**Caviness Land ELEVATIONS**

PLAN: CL 310T

**Caviness Land**

**FIRST FLOOR PLAN**

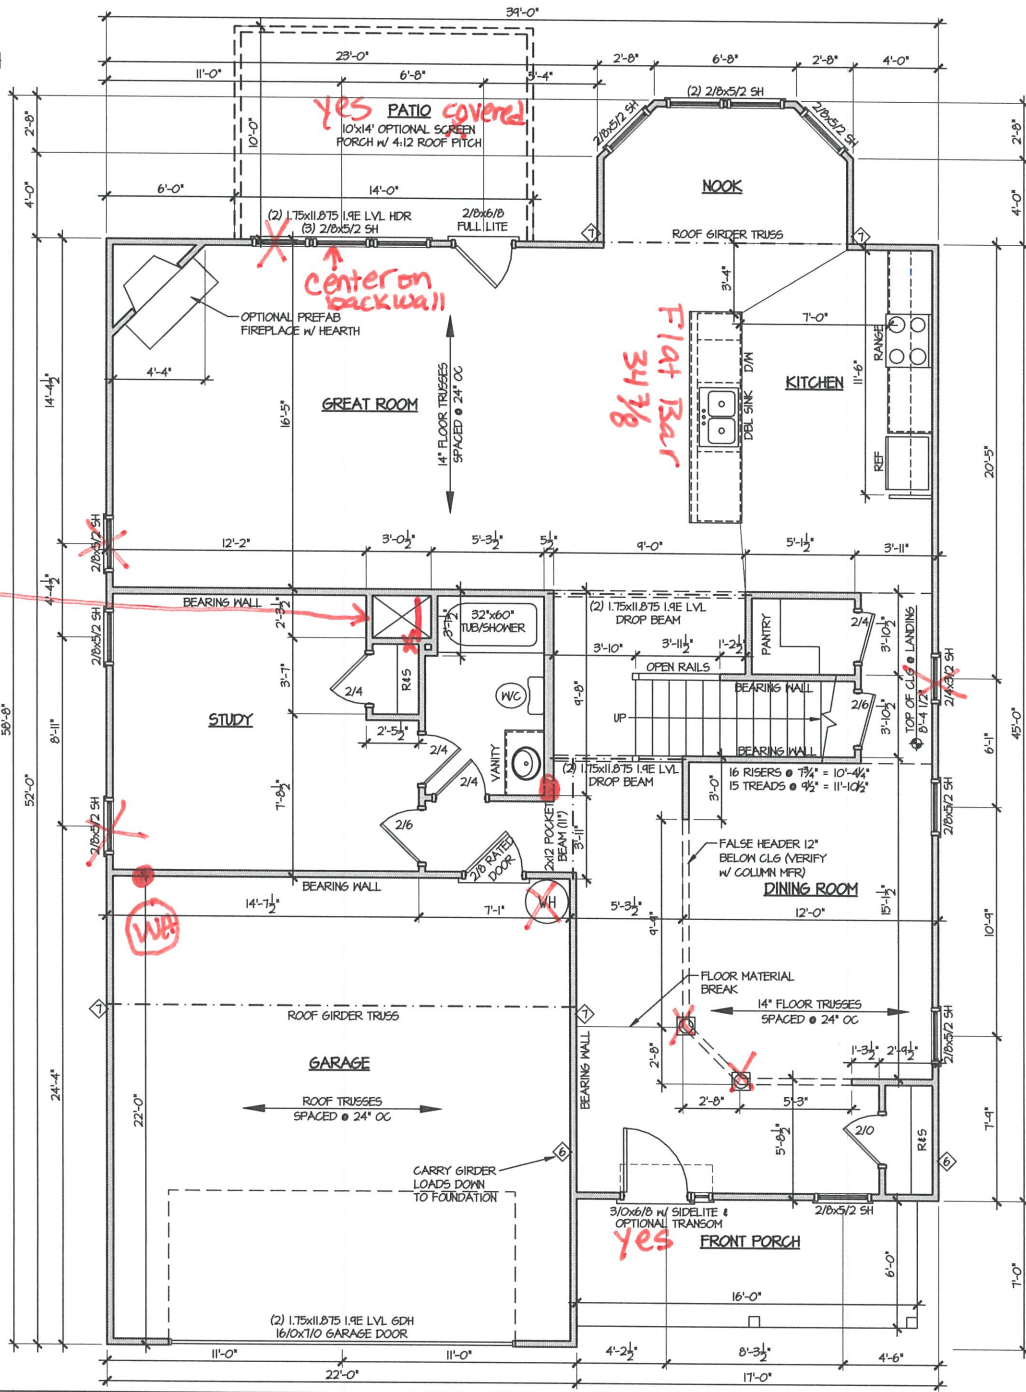
Plumbing drops

CHECK BOX FOR:  
 SCREEN PORCH

make full  
 cidset do not need d/c

Caviness Land  
SECOND FLOOR PLAN

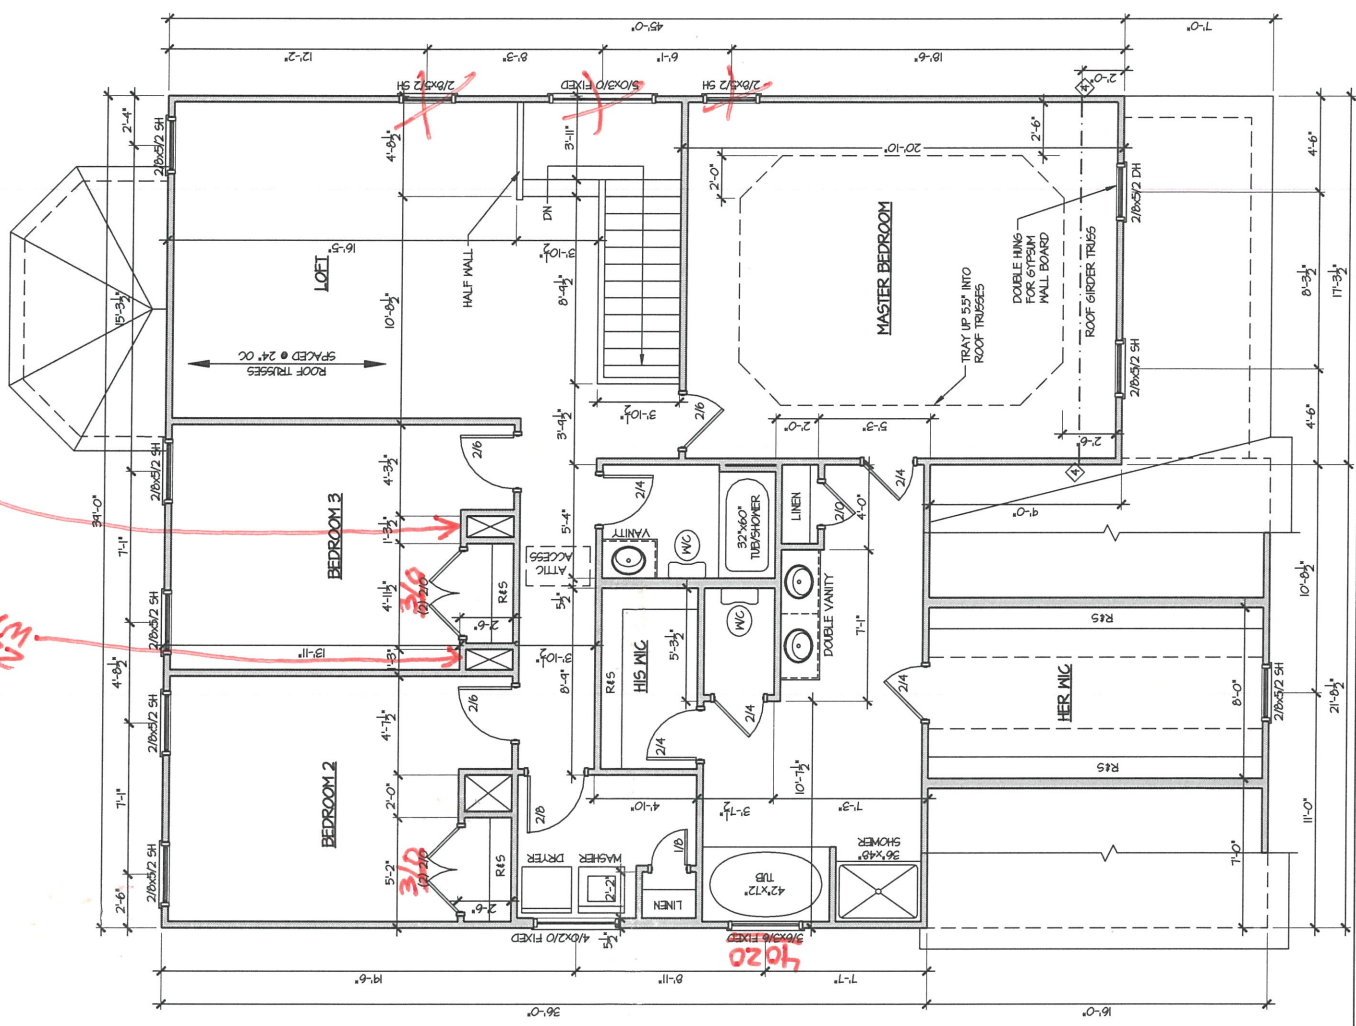
REMOVE  
22\"/>
